REVIEW OF REMEDIATION ALTERNATIVES FOR THE ANVIL RANGE MINE COMPLEX FINAL REPORT

The Independent Peer Review Panel

April 2007

Figure I Proposed Single Groundwater Capture Option

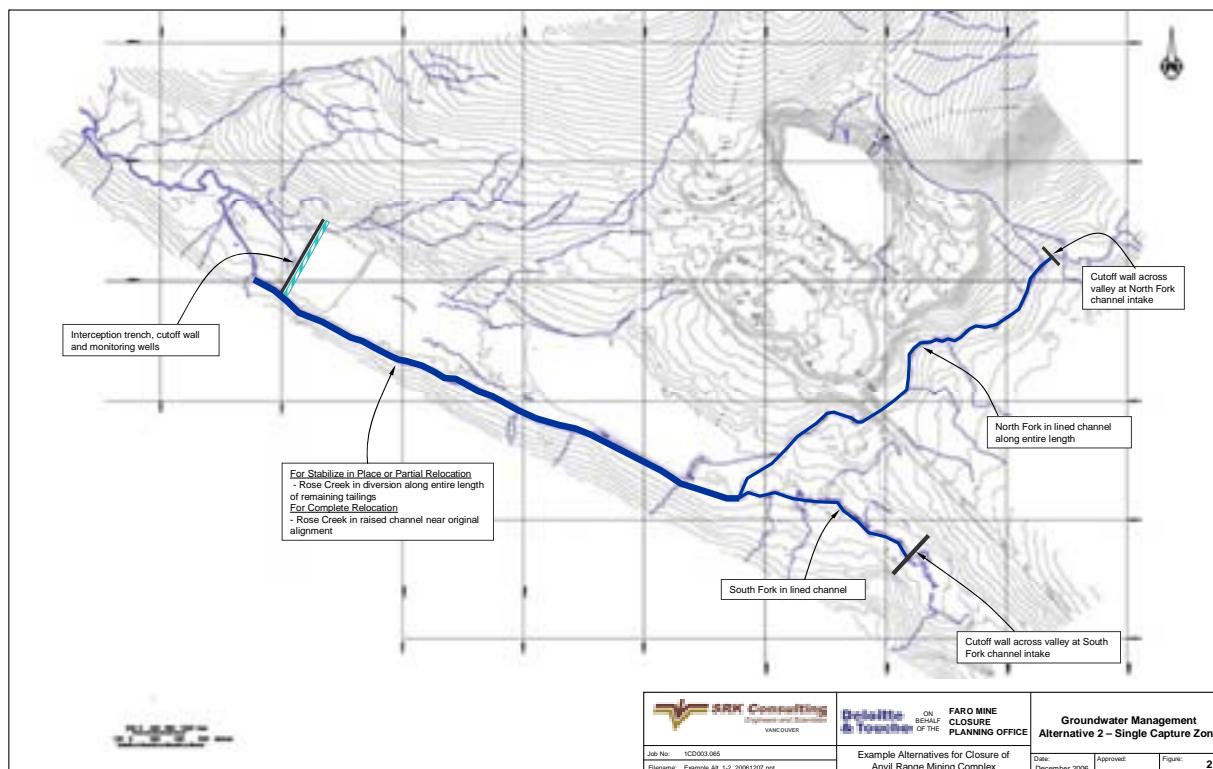
To provide greater certainty of achieving very high groundwater load capture efficiency at the RCTF, the Panel has proposed a groundwater capture option that relies on surface pumping from a permeable recovery trench or horizontal drain with fully penetrating relief wells near the Cross Valley or Intermediate Dams and a down-gradient cut-off wall installed into bedrock as necessary.

This modified groundwater capture option would include an emergency storage pond to address inevitable pumping system malfunctions and breakdowns and up-gradient cut-off walls to minimize the amount of clean groundwater entering the aquifer beneath the RCTF. The modified groundwater capture option proposed by the Panel is presented on Figure I.

Figure III Proposed Water Cover for the Rose Creek Tailings

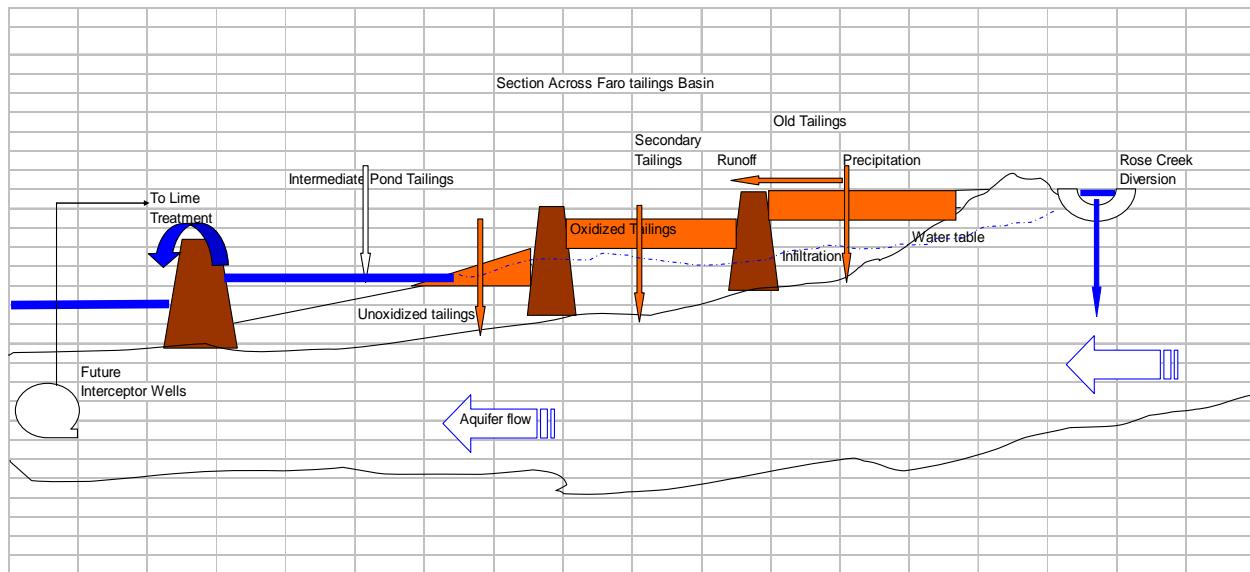
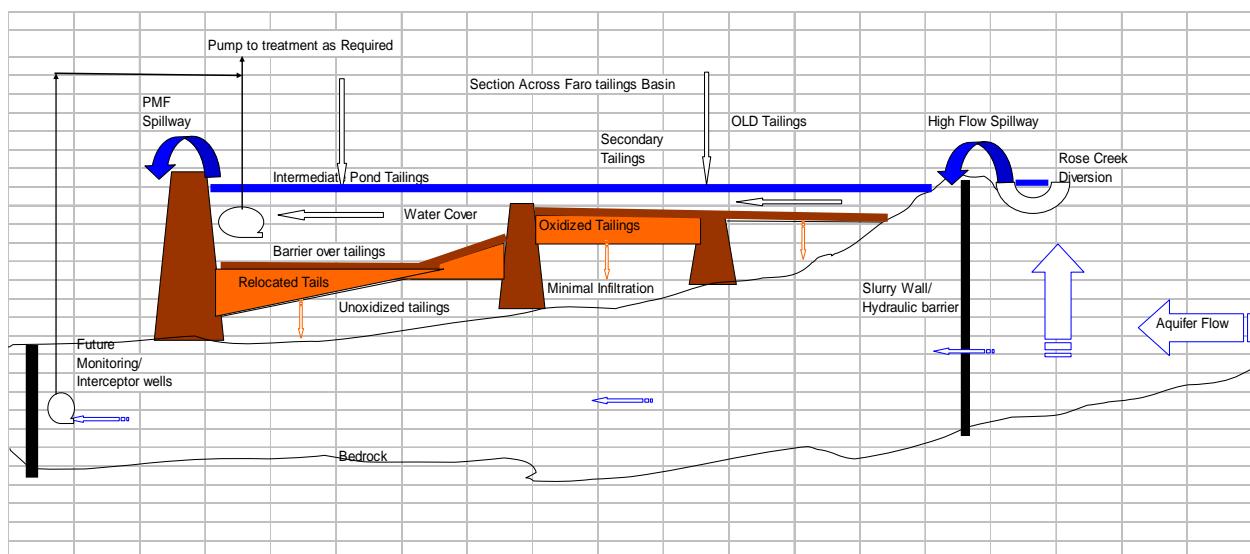
Conceptually, the proposed wet cover option for the RCTF is illustrated in Figures II and III. A preliminary cost estimate indicated this option was similar in magnitude to that of the dry cover, although further assessment is needed to provide a more equitable comparison on economic and environmental benefits and impacts.

Figure 1 Disturbed Areas Associated with the Faro Mine Site

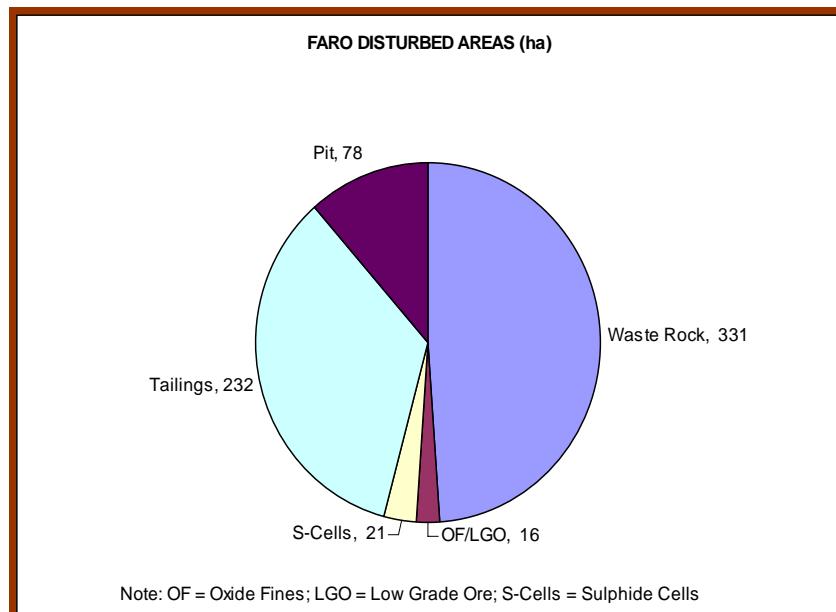
As seen on Figure 1, on one hand the lower sulphide waste rock piles account for 331 hectares or nearly half of the total disturbed surface of the area but only a small portion of the total mass load of zinc unless the Future 3 geochemical scenario is attained. On the other hand, the sulphide cells, oxides fines, and low grade ore (LGO) stockpile account for only about 5% of the total disturbed area but the majority of the mass load of zinc in the Future 1 and 2 Scenarios. On Figure 2 the projected mass load contributions for zinc from various sources at the Faro Mine site are presented in relation to the three future scenarios.

Figure 2 Contribution to the Estimated Mass Load of Zinc over Time

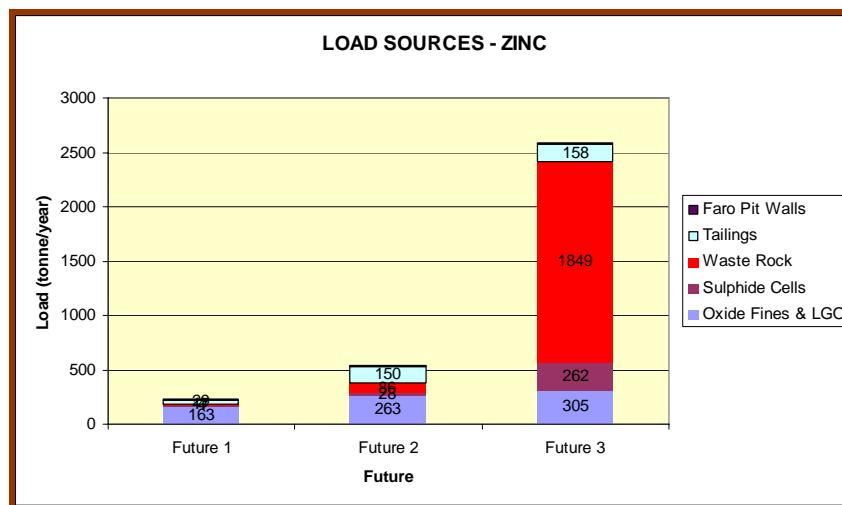
Several observations can be drawn from these figures. First, there is a dramatic rise in the mass load of zinc exiting the Faro Mine WRDs if the Future 3 geochemical scenario becomes a reality.

Figure 8 Water Cover Concept for the Rose Creek Tailings

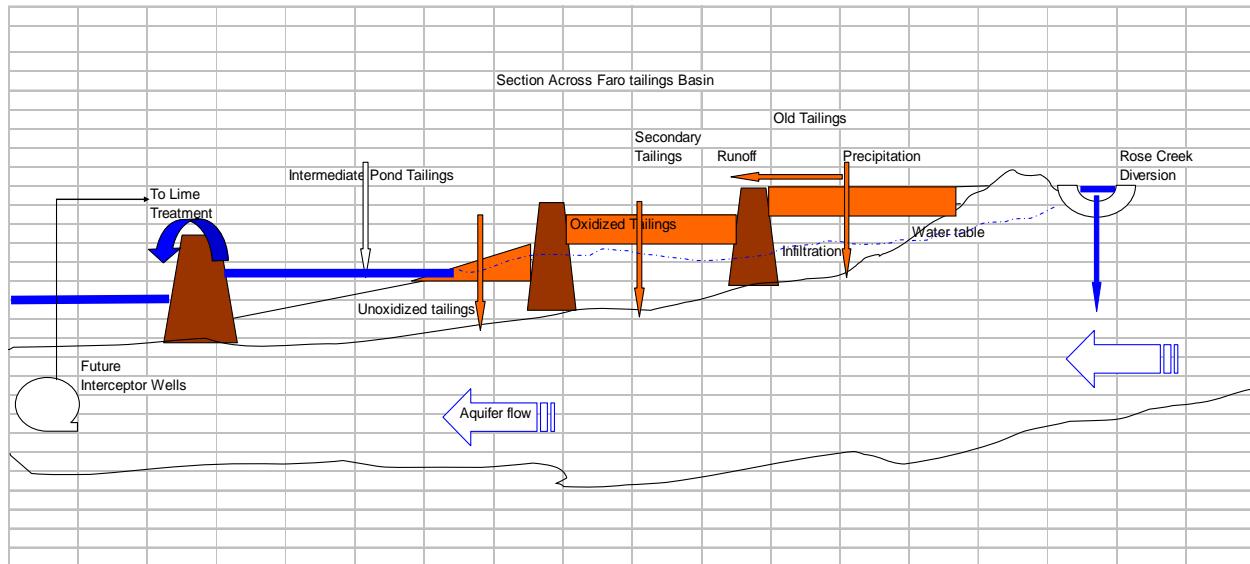
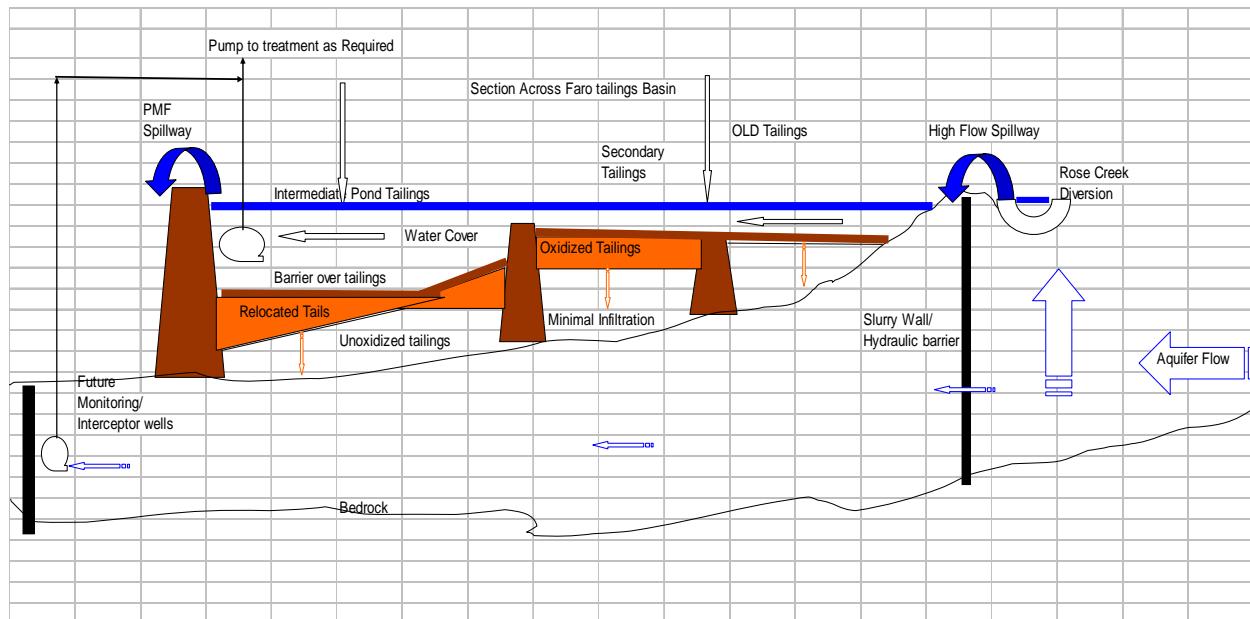
Flooding has been applied or proposed as a management option for reactive wastes at sites throughout the world. It is our understanding at sites where this remediation approach has been applied sulphide oxidation can be controlled effectively. This includes tailings which may be in advanced stages of acid production. In these cases, basins were limed after relocation and no further acid release to the pond was observed. In order that acidic salts are not released, the tailings seepage gradients must be controlled and this may be achievable at the Faro Mine site if slurry walls were constructed in the aquifer upstream and downstream of the tailings. A potential flooding option could consider as shown in simplified format on Figures 7 and 8:

- The relocation of a portion of the tailings from the old and secondary tailings to the intermediate tailings basin. These tailings could be relocated in the dry (mechanical) or wet (hydraulic) and all tailings covered with a barrier.
- The Intermediate dam would be raised to flood the tailings.
- Seepage cut-off walls would be installed in the aquifer up gradient and down gradient of the tailings impoundment to isolate the stored acidity and metals in the basin. With minimal seepage, there will be minimal gradient to remove the stored acid inventory from the basin.
- Rose Creek would be diverted in a channel over the tailings
- A new PMF spillway constructed to accommodate the Rose Creek diversion.

If the tailings are flooded, much of the Rose Creek diversion could be designed for a lesser design storm and higher floods allowed to breach the Rose Creek Diversion at the fuse plug and pass over the flooded tailings area. It would be necessary to prepare the surface of the tailings impoundment to route floods from Rose Creek across the surface of the tailings.
